**CITY OF WEST DES MOINES
BOARD OF ADJUSTMENT COMMUNICATION**

Item: Iowa Christian Academy Field House, 2296 Grand Ave – Approval to construct an approximately 20,000sf gymnasium and future 12,000sf building addition – Iowa Christian Academy - PC-002074-2014

Requested Action: Approval of a Permitted Conditional Use Permit

IOWA CHRISTIAN ACADEMY FIELD HOUSE - LANDSCAPE PLAN

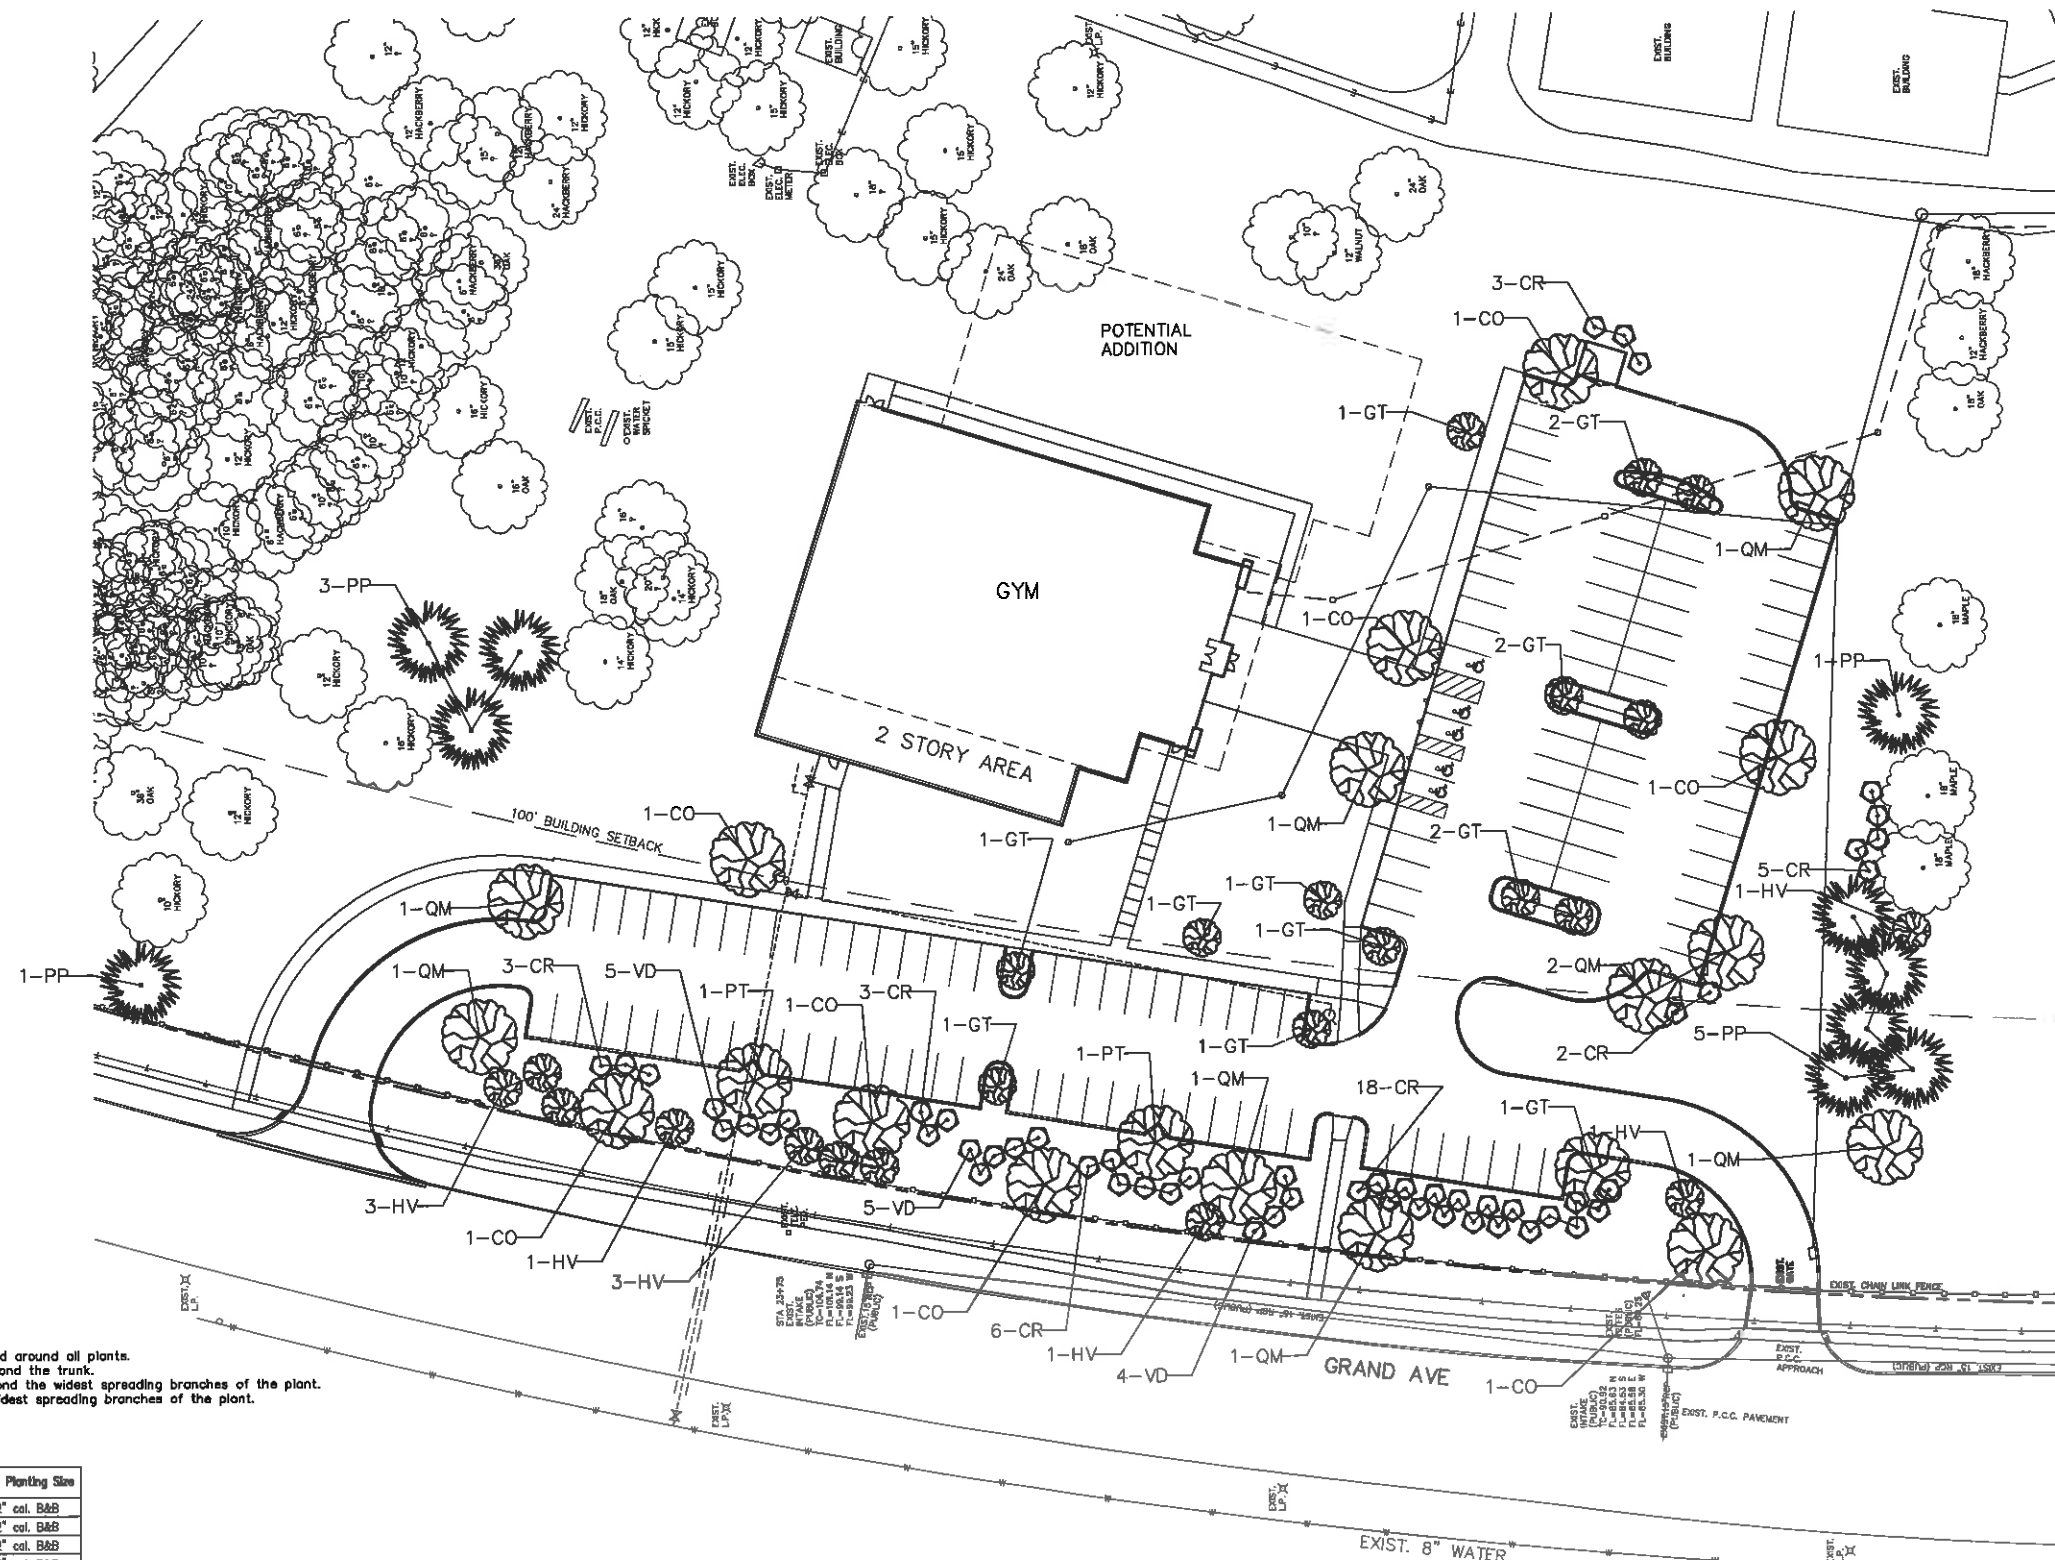
- **Parking Lot Landscaping:** The applicant is providing parking lot landscaping consistent with city code for the incorporation of landscape islands and tree pods in the parking area located along Grand; however, not in the parking field located south of the main entrance. Due to topography of the lot and channeling of storm water along the curb lines, the applicant is requesting that they not be required to implement islands or pods as this would impede the water flow. The applicant has located the minimum number of trees that would otherwise be required in islands or pods immediately adjacent to the parking field. The applicant is requesting this vegetation located immediately outside of the parking lot/sidewalk edge be accepted as meeting the intent of code in respect to the incorporation of landscaping for shade and visual softening of expanses of paving within parking areas. The applicant has located a landscape island within the middle parking rows within the lot south of the entrance which otherwise would not be required by code in order to provide additional trees within the lot and compensate for no islands along the parking lot edge.

5. The Board of Adjustment accepting the placement of landscape vegetation immediately adjacent to the edge of the parking lot located south the proposed gymnasium as meeting the intent of the

incorporation of landscape islands and tree pods for the placement of trees to provide shade and otherwise visually soften the expanses of parking lot paving;

EAST ELEVATION - WEST DES MOINES, IOWA

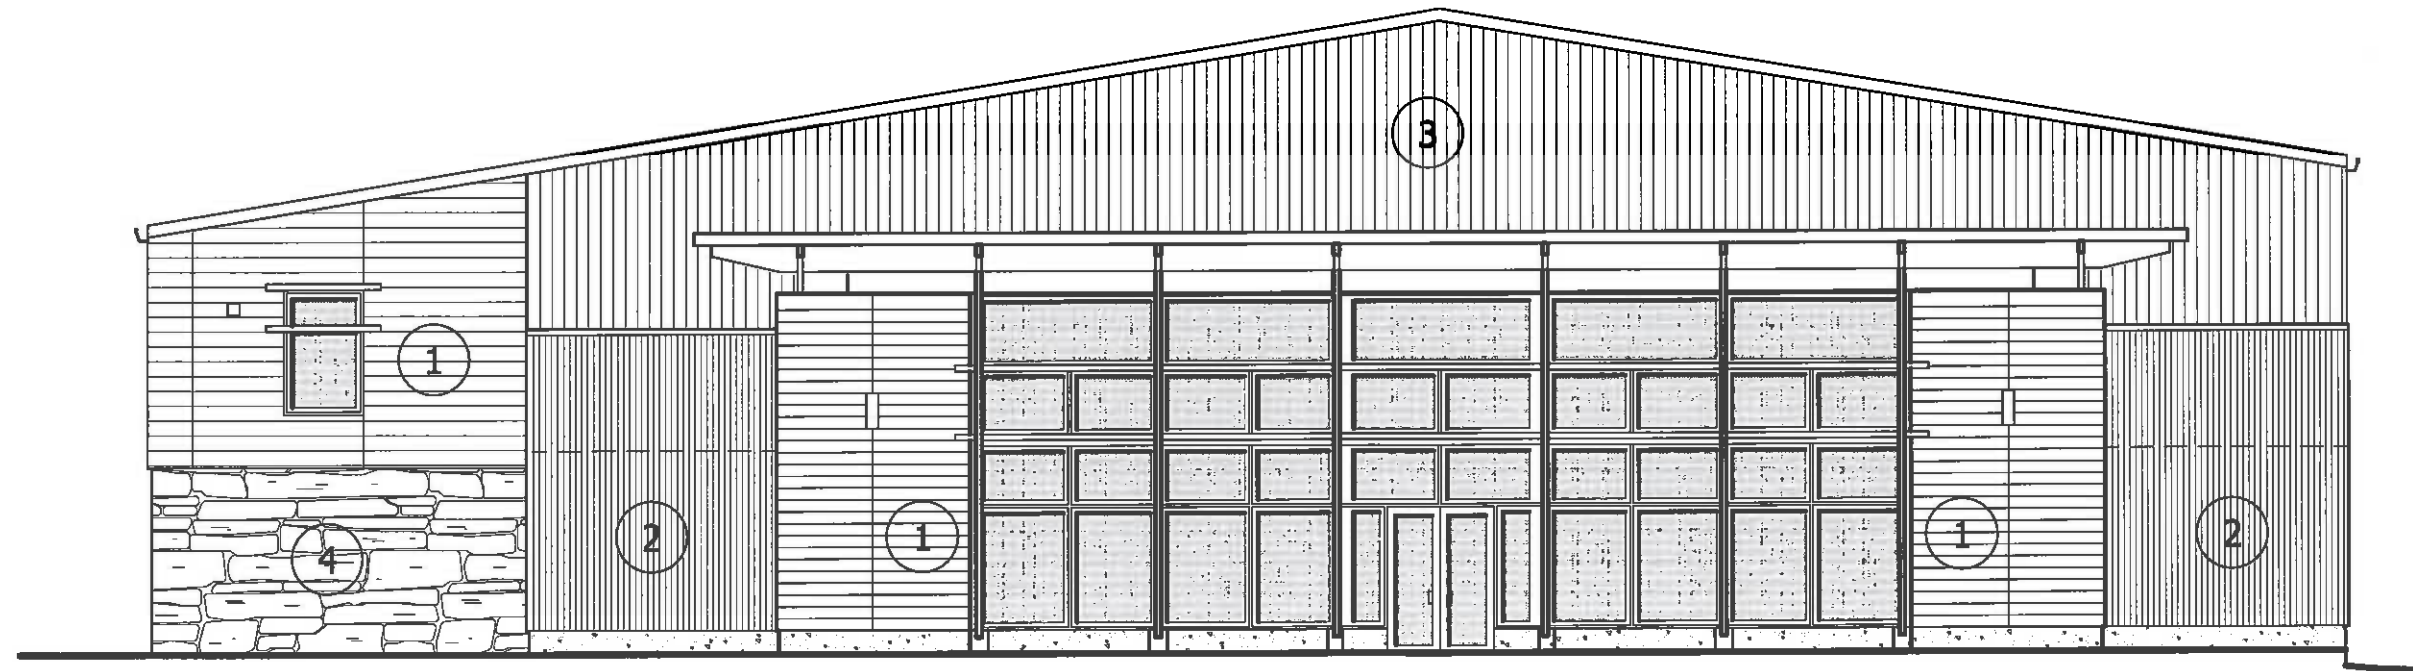
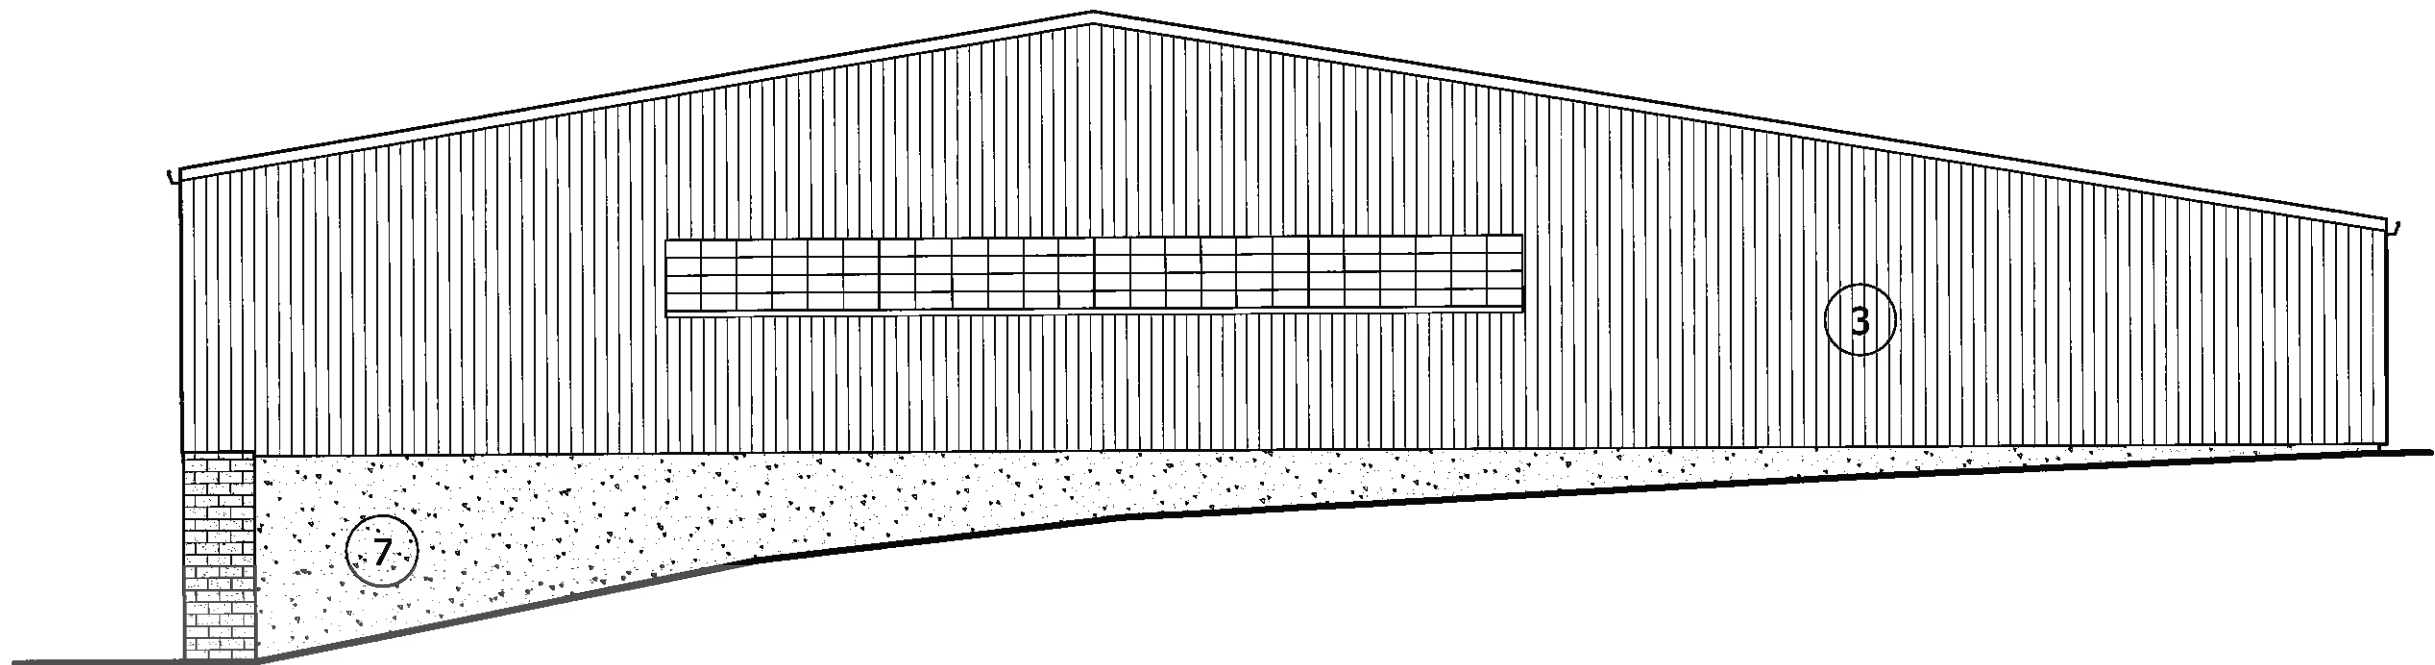
generally in agreement with that proposed. Staff's concerns rest primarily with the north and east facades which, as proposed, are predominately metal. Staff is requesting direction from the Board of Adjustment regarding whether the current proposed architectural design and use of materials is acceptable or if further modifications to reduce the amount of visible metal is warranted. Staff has recommended a condition of approval which requires the applicant continue to work with staff in regards to architecture. If the Board determines the current design is appropriate, the condition of approval will need to be removed as part of the Board's motion for approval of the project.

1. The applicant continuing to work with city staff to create a building design which further minimizes the amount of visible metal consistent with the direction of the March 27, 2014 Development and Planning City Council Subcommittee stated preference to implement a building that is not characteristic of an agricultural building;
